<b>Title of Change:</b>	Remove blue band mark for QEB373 series
<b>Effective date:</b>	09 Jun 2024
<b>Contact information:</b>	Contact your local onsemi Sales Office or <a href="mailto:Esther.Lau@onsemi.com">Esther.Lau@onsemi.com</a>
<b>Type of notification:</b>	This Product Bulletin is for notification purposes only. onsemi will proceed with implementation of this change upon publication of this Product Bulletin.
<b>Change Category:</b>	Remove blue band mark for QEB373 series
<b>Change Sub-Category(s):</b>	Remove blue band mark for QEB373 series

Pin orientation as indicated in datasheet:

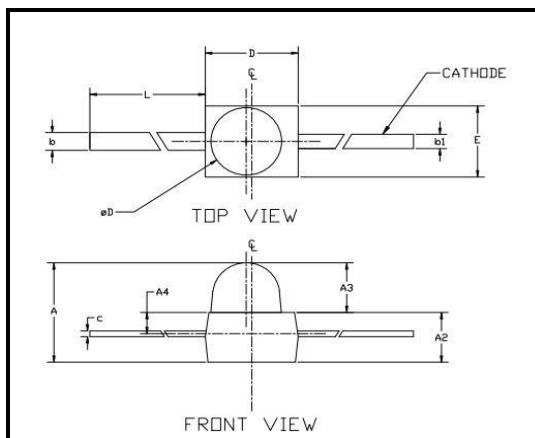
This Product Bulletin documents the removal of the blue marking at cathode side at the bottom of QEB373 series T-3/4 package. Pin orientation is already indicated in the datasheet.
